Subject: ELECTRIC POWER RESEARCH INSTITUTE – SUBMITTAL OF RESPONSES TO THE US NRC’s REQUEST FOR ADDITIONAL INFORMATION (MAY 2025) ON EPRI TECHNICAL REPORT 3002028939, “RISK-INFORMED HIGH-ENERGY LINE BREAK EVALUATION REQUIREMENTS”.

ATTACHMENT 1 – RAI RESPONSES ON TR 3002028939

ELECTRIC POWER RESEARCH INSTITUTE REPORT 3002028939, "RISK-INFORMED HIGH-ENERGY LINE BREAK EVALUATION REQUIREMENTS"

REQUESTS FOR ADDITIONAL INFORMATION

Figure 2-2. RI-HELB methodology overview

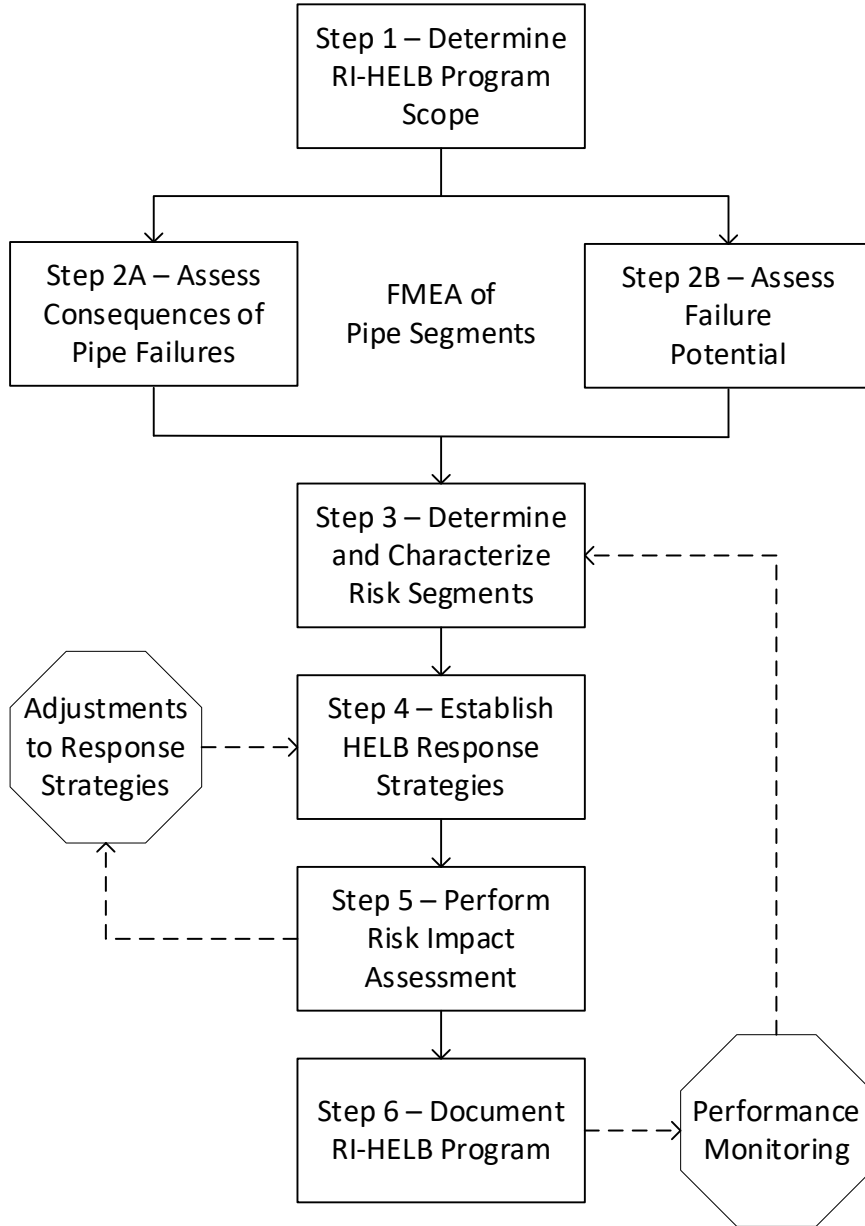
- b. NUREG-0800, Section 3.6.3, Revision 1, March 2007, states that an evaluation over the entire life of the plant for the plant piping system include environmental conditions. Does this apply to EPRI TR 3002028939? Please explain the reasoning.

Section 2.6 of TR 3003028939 will be updated to add the following words. In addition, Figure 2-2 (RI-HELB methodology overview) will be updated requiring the adjustment of HELB response strategies if delta risk is not met.
